March 31, 1995

SUBJECT: LaSalle County Nuclear Power Station Unit 2  
Request for Emergency Technical Specification Amendment  
Facility Operating License NPF-18  
Emergency Safety/Relief Valve Opening Setpoint Tolerance Change  
NRC Docket No. 50-374

### **DESCRIPTION AND SAFETY ANALYSIS OF THE PROPOSED CHANGES**

FIGURE 1

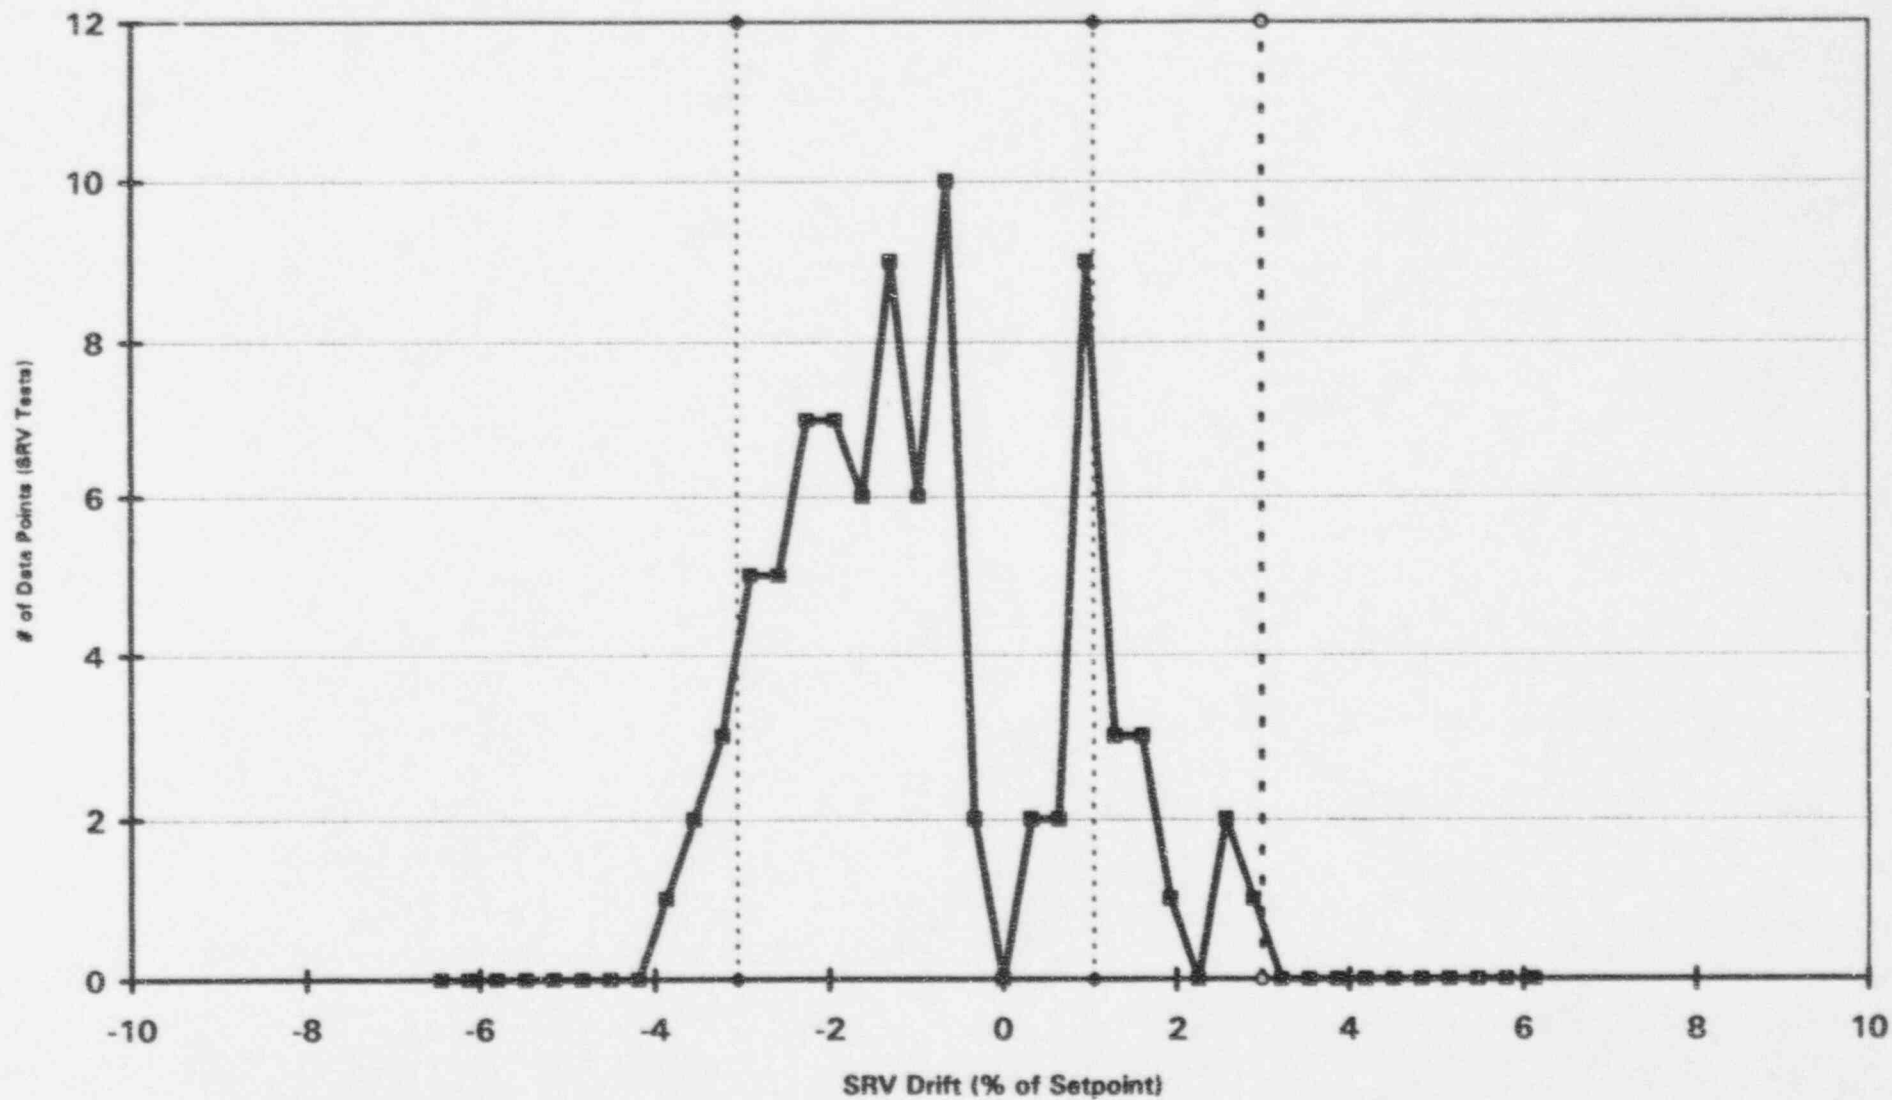
tests showed that two of the additional three valves tested, also opened at pressures outside of the allowable tolerances. All of the four valves that failed, lifted at pressures greater than 1% above the nominal safety function lift settings. A summary of the historical valve testing data through the current Unit 2 refueling outage is shown in Figure 1. Each test value shown in this graph represents the worst of the first four tests for a given valve during one testing cycle. Data demonstrate the historical as-found opening setpoints for LaSalle Station follow an expected statistical distribution.

Of the six valves in the initial sample, whose results were obtained March 18, two were considered as-found failures per the LaSalle testing procedure. However, only one failed on the initial lift. The other valve was within tolerance on the first lift, but failed the second and third lifts (the lift pressure on the third lift was 3.3% above the valve setpoint). Of the three valves tested subsequently, two valves were considered failures by LaSalle's procedure, but only one failed during the initial setpoint test. Thus, due to LaSalle's conservative testing procedure, four SRVs were considered failures even though, by current industry standards, only two SRVs would be considered failures. None of the first lift failures were above a +3% criterion.

The requested change would increase the SRV safety mode opening setpoint tolerances from  $+1\%$ ,  $-3\%$  to  $\pm 3\%$ . The as-left opening setpoints would be required to be  $\pm 1\%$ . Therefore, all tested valves must meet the  $\pm 1\%$  criterion prior to being
